TITLE SCALE
REPLACEMENT WINDOW ASSEMBLY 1:5

DRAWING NO. D3290	TITLE REPLACEMENT WINDOW ASSEMBLY	REV. C	DART AEROSPACE LTD ENGINEERING ORDER		D.E.O. NO. D3290-C-1	SHEET NO. SHEET 1 OF 1	SCALE NTS
DRAWN 92	CHECKED 5	MFG. APPR. E	APPROVED AD		DE APPR. H		
DATE 09.09.18	DATE 09.09.18	DATE 09.09.18	DATE 09/09/21		DATE 09/09/21

PURPOSE:

CHANGE MATERIAL THICKNESS OF D3290-1 FRAME TO 0.063 FROM 0.040. REF PAR 09-033.

DRAWING NO. D3290 REV. C
SHEET 1 OF 2

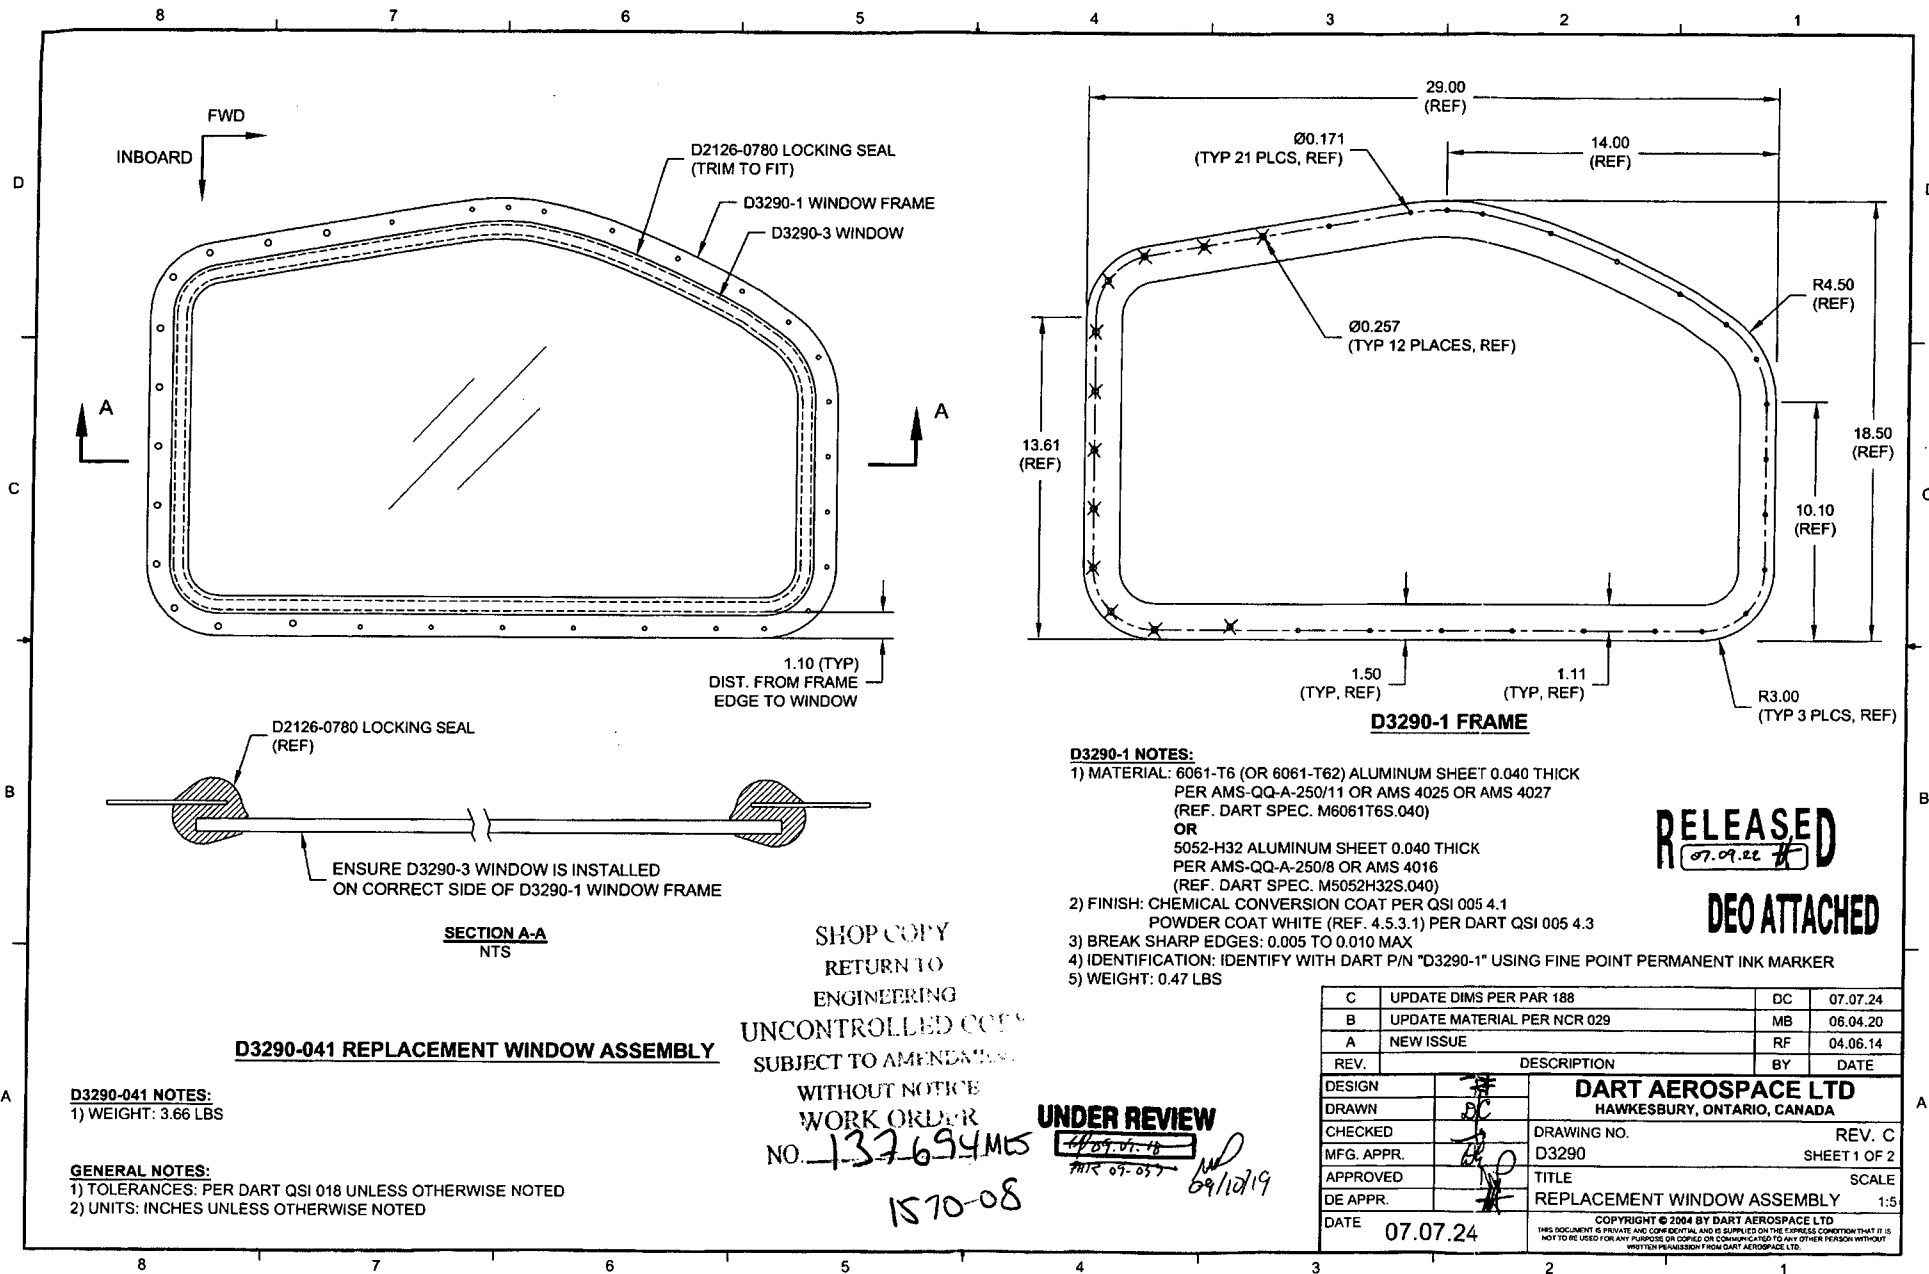
MATERIAL CALL-OUT OF D3290-1 FRAME ON SHEET 1 IS AMENDED AS FOLLOWS:

- 1) MATERIAL: 6061-T6 (OR 6061-T62) ALUMINUM SHEET ~~0.040 THICK~~ 0.063 THICK (REPLACE)
 PER AMS-QQ-A-250/11 OR AMS 4025 OR AMS 4027
~~(REF. DART SPEC. M6061T6S.040)~~ REF. DART SPEC. M6061T6S.063 (REPLACE)
 OR
 5052-H32 ALUMINUM SHEET ~~0.040 THICK~~ 0.063 THICK (REPLACE)
 PER AMS-QQ-A-250/8 OR AMS 4016
~~(REF. DART SPEC. M5052H32S.040)~~ REF. DART SPEC. M5052H32S.063 (REPLACE)
